MEMORANDUM

PROJECT: ICC Environmental Stewardship-Compensatory Mitigation Projects PB-114A and PB114/115

REVIEW TYPE: Mandatory Referral No. 10001-SHA-1: ICC Environmental Stewardship

RECOMMENDATION: Approve the construction of two Upper Paint Branch Special Protection Area (SPA) Best Management Practice (BMP) Environmental Stewardship projects; one is a new stormwater management pond (PB-114A) located within the Peachwood Neighborhood Park and the other (PB-114/115) is a series of biotrench facilities in Department of Transportation (DOT) Right of Way (ROW)

Appendix 5 – PB-114A Concept 3

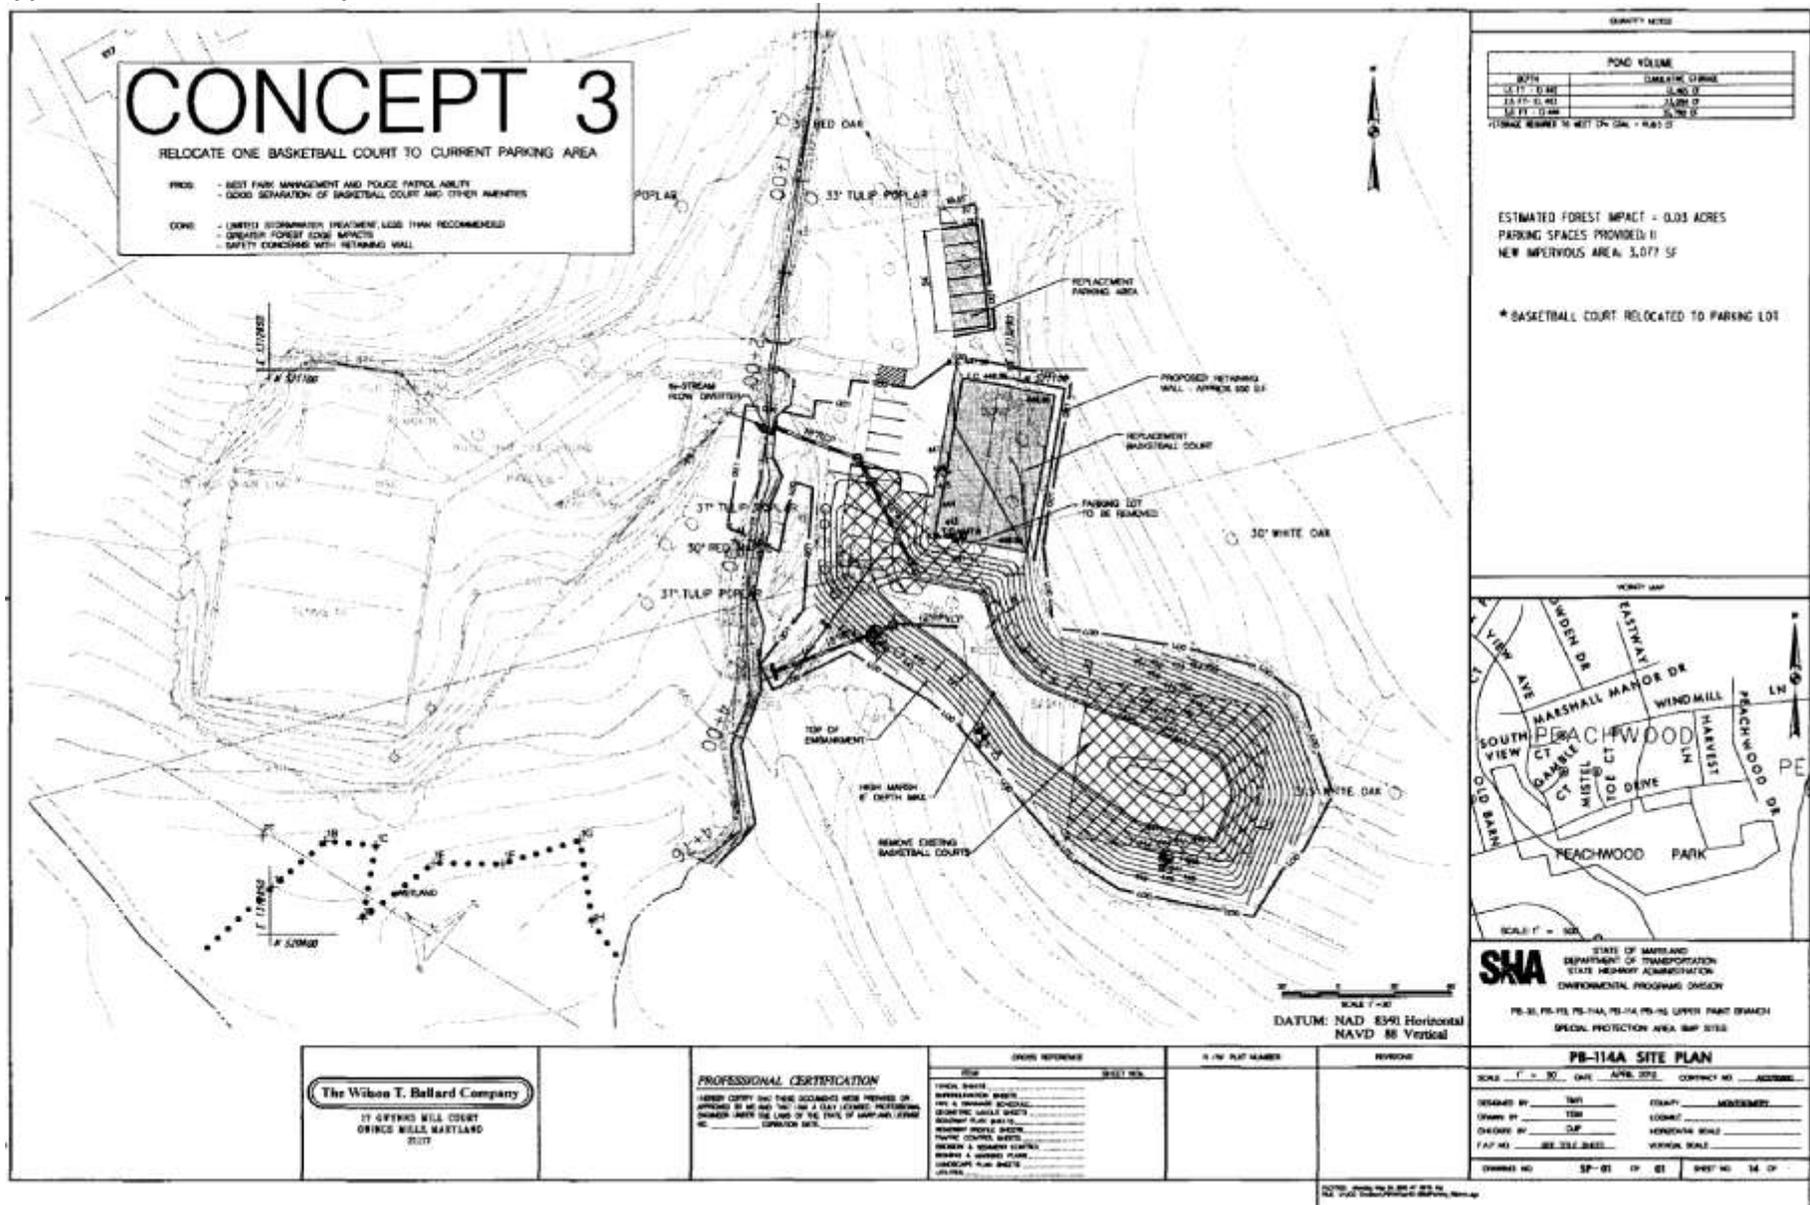
Please be advised that we prefer Alternative Plan 3 in which one basketball court would be relocated directly adjacent to and on the east side of the modified park parking lot. This alternative was favored because it comes closest to the requirements set forth in my e-mail to Karl Hellmann of M-NCPPC on May 12th which I understand he forwarded to SHA prior to the May 25th meeting to aid in the development of the alternative plans. Specifically, Alternative Plan 3 is favored because it separates the teens and adults playing basketball from the younger children using the park playground area as well as from the people using the tennis courts; it provides the Park Police with a clear sightline onto the court for safety checks, and it allows us to retain the handball court (next to the tennis courts and the playground area) to convert it into a multi-purpose play area for our children (per our discussions with the M-NCPPC representatives).

A disadvantage of Alternative Plan 3 is that the drainage pond would be somewhat smaller than in Alternative Plan 1. However, it is somewhat larger than in Alternative Plan 2, and the SHA representative indicated that although not optimal, the Alternative Plan 3 drainage pond will be adequate for storm water management purposes. Another disadvantage is that the relocated basketball court will be closer to the homes on Piping Rock Drive. However, the M-NCPPC representatives indicated that additional landscape buffering could be installed to minimize the noise impact on the Piping Rock Drive homeowners. Finally, although 0.03 acres of tree area would be disturbed under Alternative Plan 3, this is negligible compared to the tree loss caused by construction of the ICC. M-NCPPC representatives stated that transplantation of trees in the park is possible. The SHA representative also confirmed that the gradual slope of the pond will support transplanted trees. Furthermore, trees could be transplanted around the children's playground area to provide shade for the children and their parents, thereby minimizing even more tree loss.

As you can see, Alternative Plan 3 represents a good compromise between what the community wants in its park and what the SHA needs to do about storm water management. The advantages are substantial with relatively minimal disadvantages. Accordingly, we reject Alternative Plans 1 and 2 which in comparison to Alternative Plan 3 have substantial disadvantages with relatively minimal advantages. Your confirmation that Alternative Plan 3 will be the selected re-development plan for Peachwood Park will be appreciated.
